Applicable to: Hydrant couplers that utilize fuel reference pressure in lieu of air reference pressure, including 64803 and 64903

Field Modification of the Vent Port

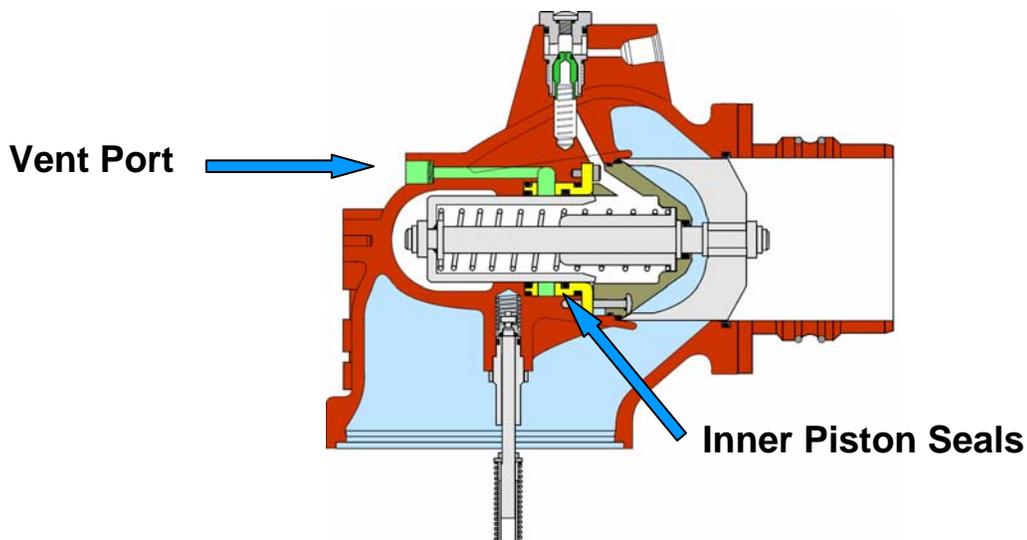
All Eaton Carter® brand hydrant couplers, except for the 60600 series of couplers, include a vent port (please review the image below). This vent port is intended to allow any fuel that leaks by the inner piston seal to be exhausted. This is done to prevent cross-contamination of the air reference pressure with fuel in air operated couplers, including the 64800, 64801, 64900 and 60700-1. This vent is also present in fuel reference pressure operated couplers, including the 64803, 64903 and 64702. The purpose of this vent on these couplers is to act as a tell-tale if the inner piston seals were to become damaged or excessively worn and begin to leak. We would also note that, even with the seals in good condition, there may be some small amount of leakage. This small amount of leakage will manifest itself as a stain around the vent port or minor weeping. The seals around the inner piston will not remove all of the fuel from the surface of the piston. When the unit is in operation the inner piston will oscillate, opening and closing to maintain the downstream pressure. As this occurs small

amounts of fuel will be wiped off the piston and remain in the void area between the inner piston seals. Given enough time, this fuel will accumulate and the slight weeping or staining of the area around the vent port can occur. This phenomenon is more common on fuel reference operated couplers as the amount of fuel that can be deposited in the void area between the inner piston seals is effectively doubled. However, as cross-contamination in a fuel-over-fuel system is not a concern, tapping and plugging the vent port may prevent a coupler from being unnecessarily removed from service due to a perceived leak. We have recently completed testing and determined that this vent may be plugged on fuel reference operated couplers, including the 64803 and 64903. **The vent port on the 64702 can not be plugged due to the shape of the vent port. This field modification should not be accomplished on air reference operated couplers as this would circumvent the primary purpose of the vent to prevent cross contamination of the air reference pressure system.**

The first step will be to inspect the raised area around the vent port opening. You may find that the original vent port is not centered in this raised area. Measure the area with the thinnest wall thickness. If the thinnest portion is less than .100", that housing can not be modified. For those couplers with a wall thickness greater than .100", remove the pressure control elbow from the coupler lower half and remove all internal components of the control elbow, leaving the vent port filter and retainer in place. The current hole is the appropriate size to accept a 1/4" NPT tap. Obtain a good quality 1/4"-18 NPT tap. You will note that the depth of the hole up to the filter disc will be deep enough for 1/4" NPT threads. Some brands of tap will have a tapered point on the leading end. Depending on the brand of tap that you have it may be necessary to grind this tapered point flat.

Measure the depth of the hole and mark the tap, measuring from the leading end. Insert the tap in the hole and, while pressing inward, begin to screw the tap in. Use liberal amounts of thread cutting oil intended for use with aluminum - Soluble, Light Base, or Lard Oil, or Mineral Oil w/Lard, or Light Oil. Remove the tap frequently and remove metal shavings to prevent build up of metal shavings from damaging the threads. Continue to screw in the tap up to the measured mark. Remove the filter screen and retainer. Remark the tap for this new depth and tap to that depth. Clean the threads and insert a 1/4" pipe plug to check the threads. Use an appropriate material pipe plug (stainless steel is preferred). The preferred type of pipe plug will have a low profile and will include a recessed hex socket similar to image above. Whatever type of plug is used, make sure that it has tapered threads. Some pipe plugs include straight pipe threads similar to a screw. The plug should screw into the threaded hole approximately 1/4 to 1/3 its threaded length with little effort. Some brands of NPT taps work better on blind holes than others. Bottom taps for NPT threads are not available. Some taps will have

a longer cutting edge past the first cutting thread than others. It may be necessary to grind more material off the leading end to obtain the appropriate thread depth. Use caution not to over tighten the tap. If the tap bottoms out in the hole and you continue to turn it, you can remove all of the threads from the hole.

Clean the housing and vent port threads and pipe plug to remove all metal shavings and cutting oil. Apply a good quality anaerobic type thread sealant such as Hercules Block. Insert the pipe plug and tighten. There are no torque recommendations for tapered threads. Do not over tighten. This is a tapered pipe plug in a tapered hole. Over tightening can crack the housing. The best approach is to tighten to a good snug fit and check for leaks. If the joint does leak it will be necessary to remove the plug and clean off all thread sealant. An anaerobic thread sealant will set up quickly when in contact with certain active metals such as aluminum. Apply new sealant to pipe plug and reinstall a little tighter.
